Product Change Notification / CENO-04VPCJ779

CCB 6058 Final Notice: Implement product label and inner box label changes for RN4678 device family available in 33L Module (12x22mm) package.

CCB 6058
Pre and Post Change Summary
PCN #: CENO-04VPCJ779

PRODUCT LABEL

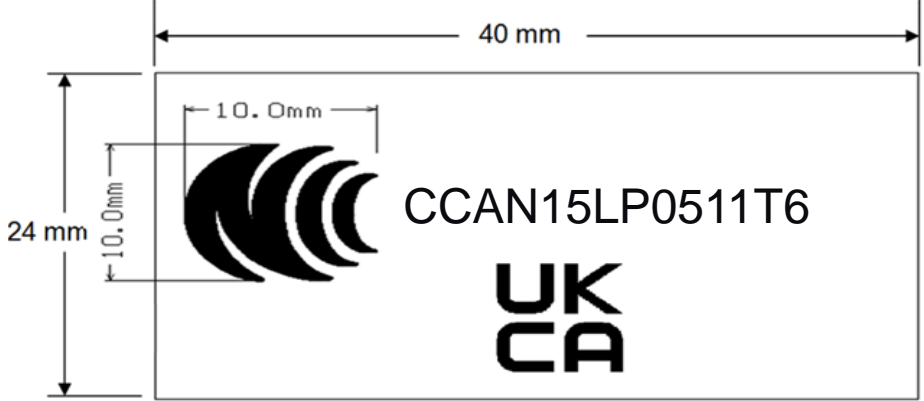
Pre Change	Post Change																								
	Remove Line4 Marking NCC ID Add Line5 ANATEL ID																								
 <p> RN4678 <MAC> YYWWNNN CCAN15LP0511T6 CMIIT ID: 2016DJ5735 </p> <table border="1" data-bbox="198 892 1133 1235"> <thead> <tr> <th></th> <th>Value</th> </tr> </thead> <tbody> <tr> <td>Microchip Customer Part Number</td> <td>RN4678</td> </tr> <tr> <td>Mac Address</td> <td><Mac></td> </tr> <tr> <td>Trace Code</td> <td><Trace Code></td> </tr> <tr> <td>Taiwan Certification Area</td> <td><NC> CCAN15LP0511T6</td> </tr> <tr> <td>SRRC Certification Area</td> <td>CMIIT ID: 2016DJ5735</td> </tr> </tbody> </table>		Value	Microchip Customer Part Number	RN4678	Mac Address	<Mac>	Trace Code	<Trace Code>	Taiwan Certification Area	<NC> CCAN15LP0511T6	SRRC Certification Area	CMIIT ID: 2016DJ5735	 <p> RN4678 4487D0715002 2211ABC CMIIT ID: 2016DJ5735 ANATEL: 07091-21-08759 </p> <table border="1" data-bbox="1375 892 2331 1235"> <thead> <tr> <th></th> <th>Value</th> </tr> </thead> <tbody> <tr> <td>Microchip Customer Part Number</td> <td>RN4678</td> </tr> <tr> <td>Mac Address</td> <td><Mac></td> </tr> <tr> <td>Trace Code</td> <td><Trace Code></td> </tr> <tr> <td>SRRC Certification Area</td> <td>CMIIT ID: 2016DJ5735</td> </tr> <tr> <td>Brazil Certification Area</td> <td>ANATEL: 07091-21-08759</td> </tr> </tbody> </table>		Value	Microchip Customer Part Number	RN4678	Mac Address	<Mac>	Trace Code	<Trace Code>	SRRC Certification Area	CMIIT ID: 2016DJ5735	Brazil Certification Area	ANATEL: 07091-21-08759

Value																								
Microchip Customer Part Number	RN4678																								
Mac Address	<Mac>																								
Trace Code	<Trace Code>																								
Taiwan Certification Area	<NC> CCAN15LP0511T6																								
SRRC Certification Area	CMIIT ID: 2016DJ5735																								
	Value																								
Microchip Customer Part Number	RN4678																								
Mac Address	<Mac>																								
Trace Code	<Trace Code>																								
SRRC Certification Area	CMIIT ID: 2016DJ5735																								
Brazil Certification Area	ANATEL: 07091-21-08759
